**3 Removal of Height Transitions for Neighborhood Compatibility –21.06.030D.8.**

**ISSUE:**

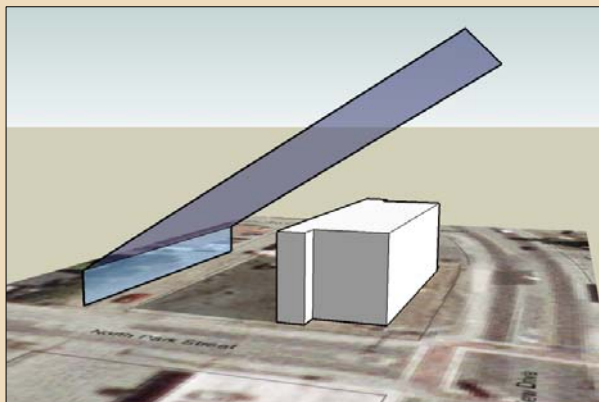
(2) Multistory structures have begun to pop up adjacent to residential areas. In the photo below, a ministorage building below backs up close to the south property line of a residential area near Tudor and Elmore.

**Height Transition Applied: Example Site 1**

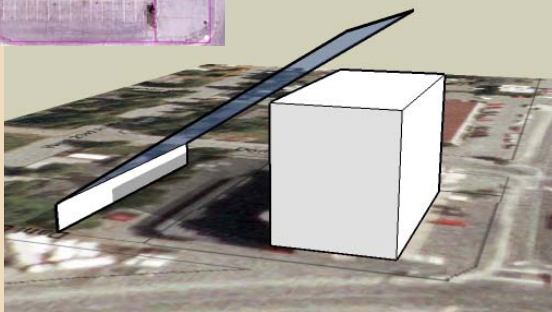
**Height Transition applied: 4211 complies easily**

Even the most shallow commercial lots backing up to residential districts have room to shift the building placement on the lot to be further away from the residential property, as demonstrated by this Cook Inlet Housing (CIHA) project.

The three story CIHA building easily passes the height transitions requirement while also maximizing the effective development potential of its lot. Parking is placed between the building and residential properties behind it.
